PO406128 Rated wall change request
 Dammon Engineering to: 'john whitaker'
 Cc: n_transp, "Dammon Engineering"

NEWMAN
 TRANSPORT LLC.
 63336
 OLD MILITARY RD
 PEARL RIVER LA.

FLOOR
 PLAN

A-1

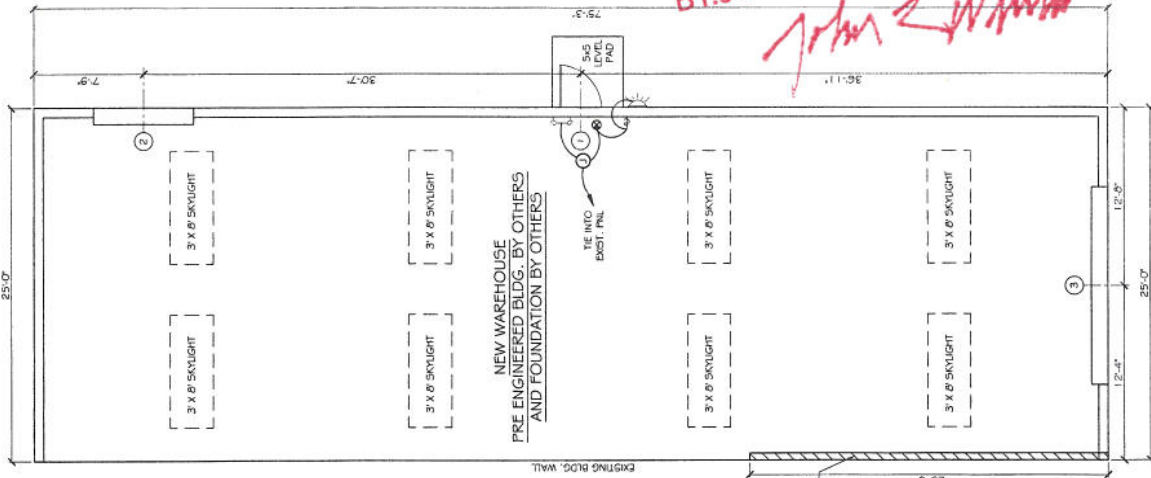
On November-29-2011 you approved a package for us (PO406128), and now we would like to use a different UL# for the wall as noted on the approved dwgs. We would like to use UL#U301 (see attached) and not GA WP 1201. Also, we were removing the non rated door on that wall, now it has been decided to reinstall a 45 minute rated door in its place.

We would like your approval on this before we proceed. Please see the attached pdfs....new wall rating U301 and the approved letter and Fire Marshall dwgs showing the location of the wall and door in question.

SEE REVISED SHEETS
 C-1 + A-1
